Kirby Morgan Dive Systems, Inc.®

Bulletin #4 of 2021. June 9, 2021

CHANGE TO PRODUCT BULLETIN

**P/N 550-046 Inlet Nipple "A" will be replaced with
P/N 850-126 Hose Adapter for the Stainless Steel Side Block**

*Previous P/N 550-046 Inlet Nipple "A," left and current
P/N 850-126 Hose Adapter for the Stainless Steel Side Block, right.*

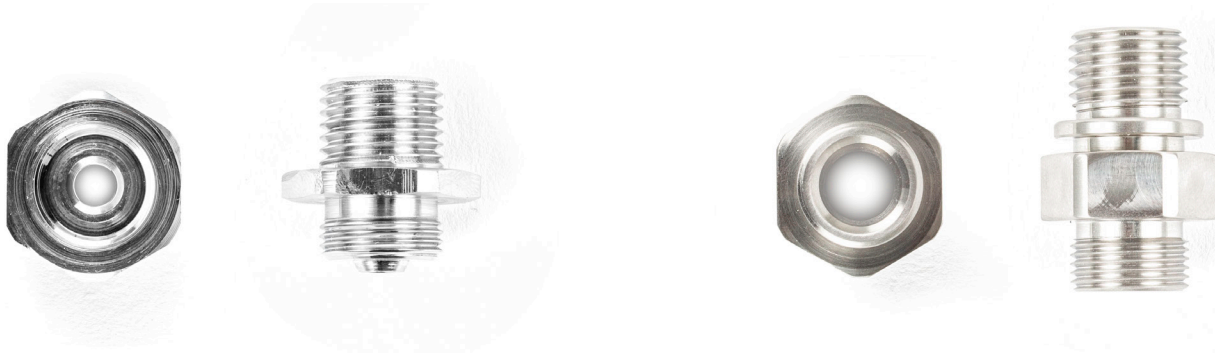
Beginning in late June 2021 we will replace 550-046 Inlet Nipple "A" with P/N 850-126 Hose Adapter.

The adapter/inlet nipple that uses standard SCUBA threads to secure bailout/EGS gas to the EGS valve has been re-designed to allow increased flow rates to the system as well as to aid in proper maintenance and service of the part. The hex has been slightly enlarged to $\frac{3}{4}$ " and also been made wider for a better wrench engagement. This change will also help prevent tool slippage that may cause damage to the part. The internal diameter has also been increased allowing for the very best work of breathing.

The new part number is 850-126 and no change to associated procedures for maintenance is necessary. Any remaining stock of the P/N 550-046 Inlet Nipple "A" can be used without issue.
